6' DIA WET WELL MEADOWS

JOB NUMBER **RMTC** 0000

CHANGED CROSS TO 4In ALL AROUND, AND ADDED REDUCER CHANGED PUMBING PORT PIPING TO 4In COMPONENT DRAWING DESCRIPTION COMPONENT DRAWING **687 VALVE VAULT** MEADOWS 3 SHEET 2 OF 2

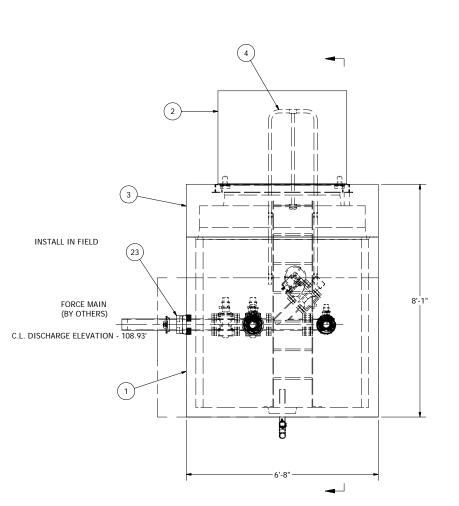
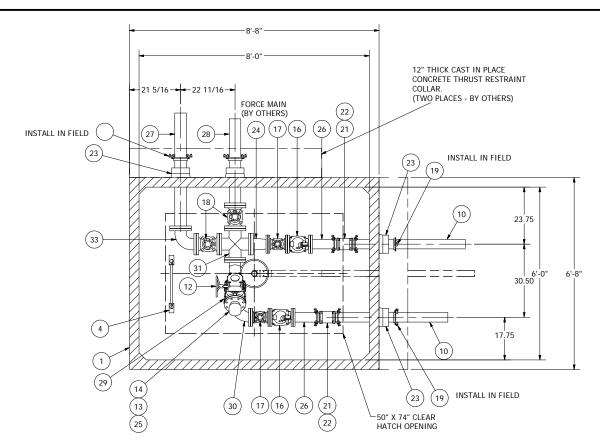
REVISED PER LAUNCH MEETING COMPONENT DRAWING DESCRIPTION COMPONENT DRAWING
